Comment

(TDL #162 from D2.1)

[Addresses D2.2 comments: 88, 288, 280, 349, 237](#)

Figure 33B-1—PSE PI unbalance specification and E2EP2PRunb

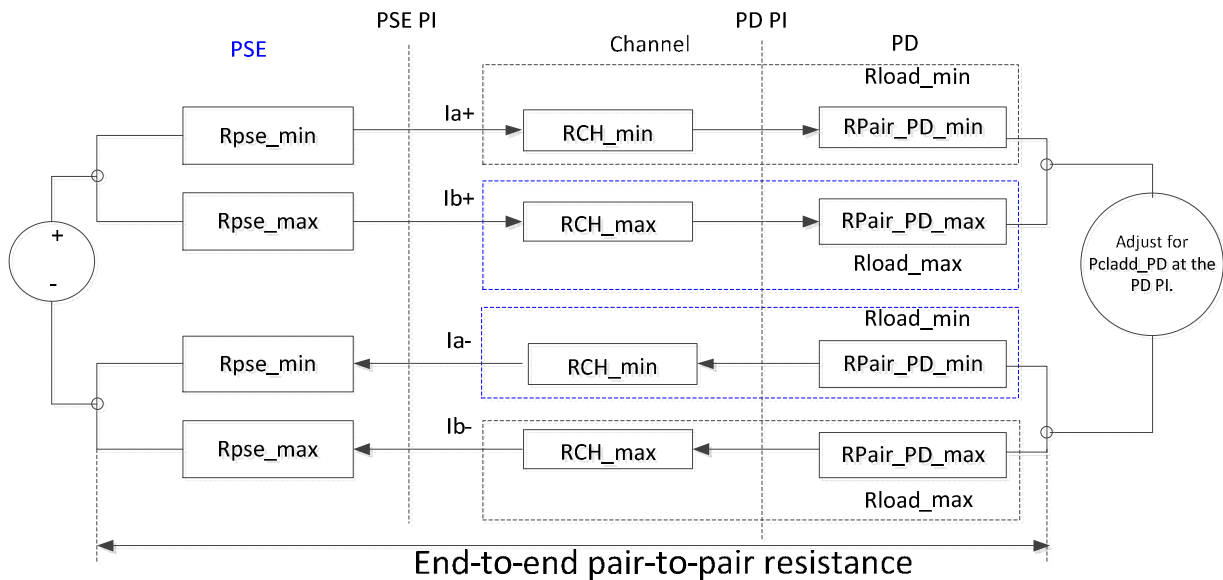
**Move Figure 33B-1 to 33.2.8.5.1 (to this location) with the marked updates.
Update Figure numbers as required.**

R_{Ch} is the maximum value of (RCH_min + RCH_max) as described in Figure 33-B1.

RCH_max is the sum of channel pair elements with highest common mode resistance and RCH_min is the sum of channel pair elements with lowest common mode resistance.

RPSE_max and RPSE_min are specified and measured under maximum PClass sourcing conditions and V_{Port_PSE-2P} operating range. R_{PSE_min} need to be greater than $\{(-\beta/\alpha)\}_{\Omega}$ according to Equation 33-15 format of $RPSE_max \leq \alpha \times RPSE_min + \beta$ in order to satisfy Equation 33-15. Conformance with Equation (33-15) shall be met for RPSE_max and RPSE_min.

Figure 33B–4—Current unbalance test circuit

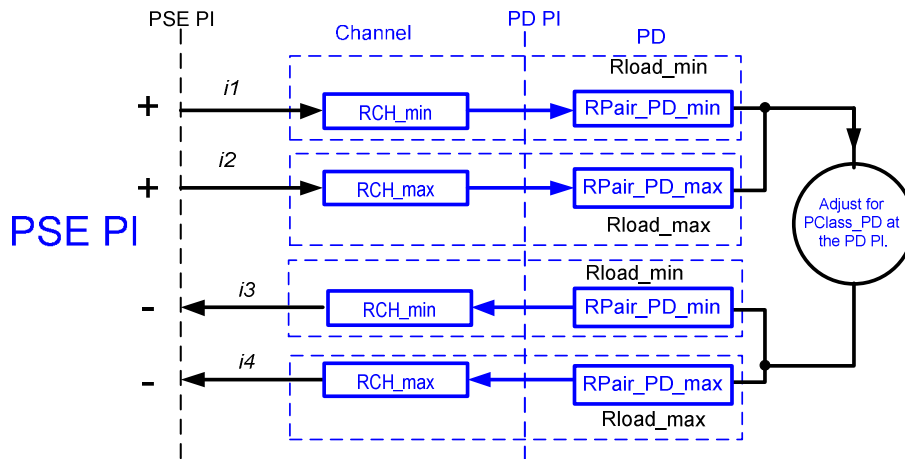
Move Figure 33B-4 to this location with the following marked updates.

The current unbalance test circuit is shown in Figure 33B-4. The test method is described below:

- 1) Use R_{load_min} and R_{load_max} from Table 33B-1 for R_{load} at low channel resistance conditions.
- 2) With the PSE powered on, adjust the load to P_{class_PD} .
- 3) Measure I_1 , I_2 , ~~I_3 and I_4 .~~
- 4) Swap R_{load_max} , R_{load_min} , repeat steps 1 and 2.
- ~~5) Repeat for I_3 , I_4 .~~
- ~~6) Verify that the current in any pair each case~~ does not exceed I_{con-2P_usb} minimum in Table 33–18.
- ~~7) Repeat steps 1-6 for R_{load_min} and R_{load_max} from Table 33B-1 for R_{load} at high channel resistance conditions.~~

Figure 33A-XX – Common mode Pair-to-pair channel resistance unbalance

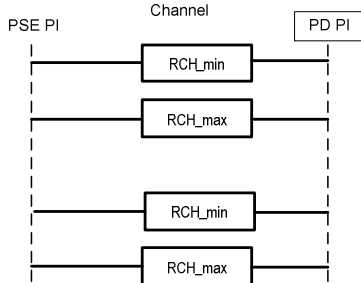
Figure 33A-XX was added to differentiate between R_{ch} term used from PSE PI to PD PI and back and the channel resistance of pair of wires and their connectors from PSE PI to PD PI (one way) that is used in this Annex and all related P2Pumb clauses.

Add Figure 33A-XX

The resistance of the common mode pairs of conductors and connectors RCH_{\min} and RCH_{\max} are described by Figure 33A-XX.

Figure 33A–4—PD resistance unbalance elements overview

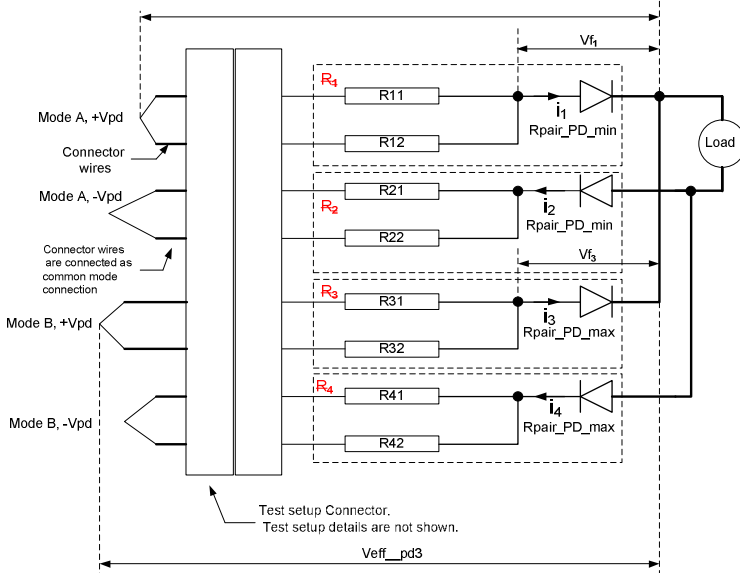
This is not part of the baseline
 We can simplify text and drawing by deleting R1, R2, R3 and R4 from the text and Figure 33A-4 since we have we have Rpair_PD_min/max definitions already in the drawing and the text.

Figure 33B-2—Direct measurements of effective $RPSE_{max}$ and $RPSE_{min}$

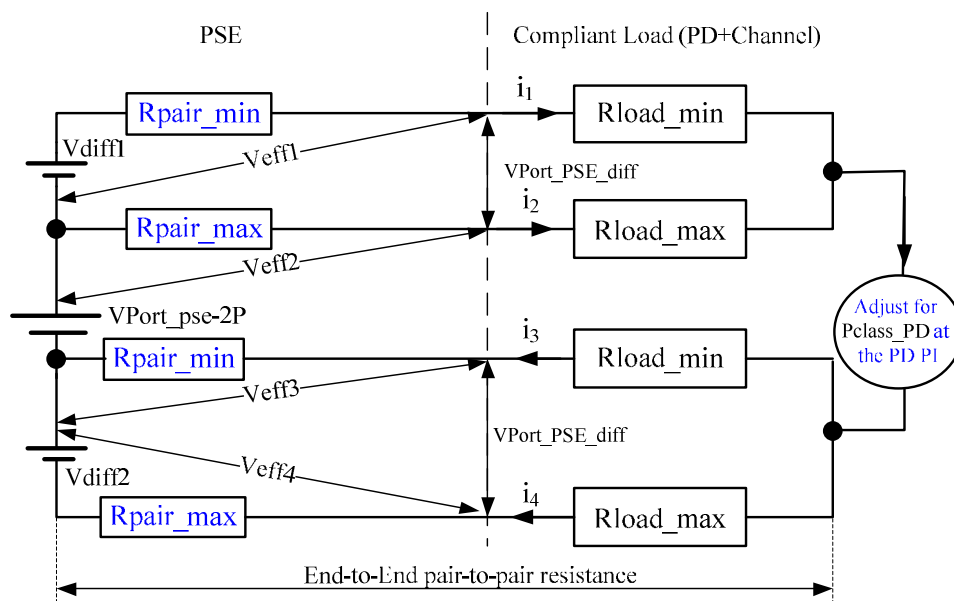
Update Figure 33B-2 as follows:

Figure 33B-3 – Effective resistance test circuit

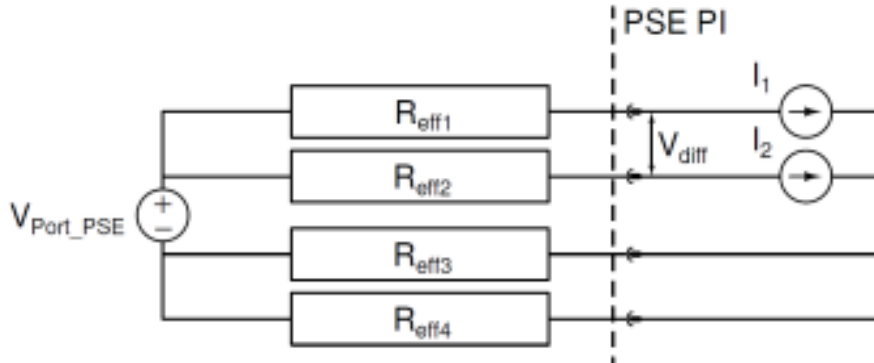
Add to TDL: Ken to verify that the following test model works in simulations
